REMARKS

Applicant has the following response to the Office Action of June 23, 2005.

Fig. 33B

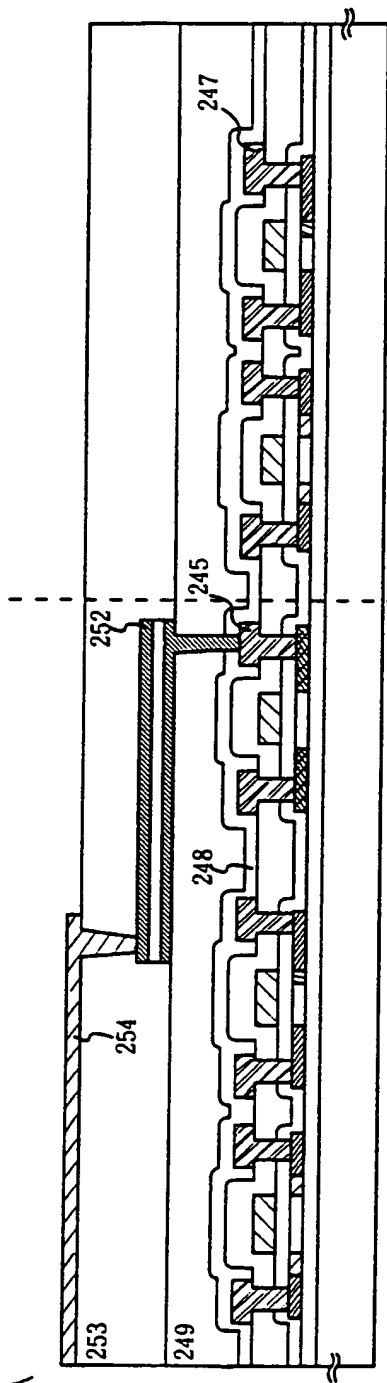
The attached sheet of drawings include changes to Fig. 33B to add reference numerals 270-274. This sheet, which includes Figs. 33A, 33B replaces the original sheet and the prior replacement sheet.

Upon review of the application and drawings, Applicants discovered that page 73, lns. 1-4 of the specification, in discussing Fig. 33B, refers to reference numerals 270-274. These numerals were inadvertently left off of the drawing of Fig. 33B. Accordingly, Applicants are amending Fig. 33B to include such numerals. No new matter is being added.
